CI 00	SC	Р	L	# 1	
Dallesasse	, John	Emcore	Corporation

As drafted, the standard allows the existance of a ""compliant"" equalizer with adaptation times too slow to ensure stable operation in an office environment. Such an equalizer needs to be excluded from the ability to claim compliance to the standard, or the standard is broken. A dynamic receiver test is required.

SC 68.6

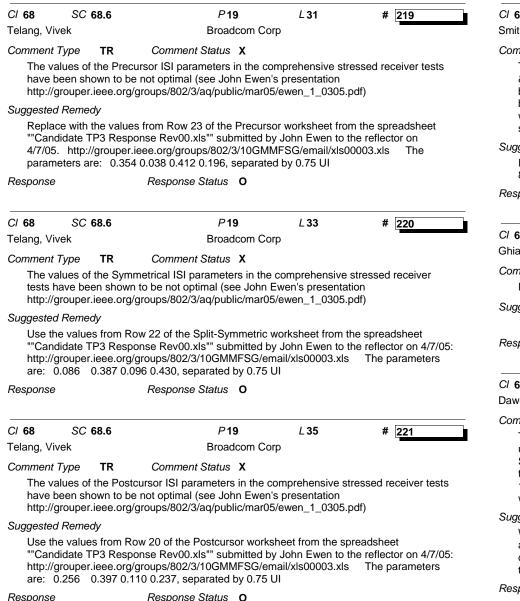
CI 68	SC 68.6	P 19	L 44	# 222
Smith, Grant		Aeluros
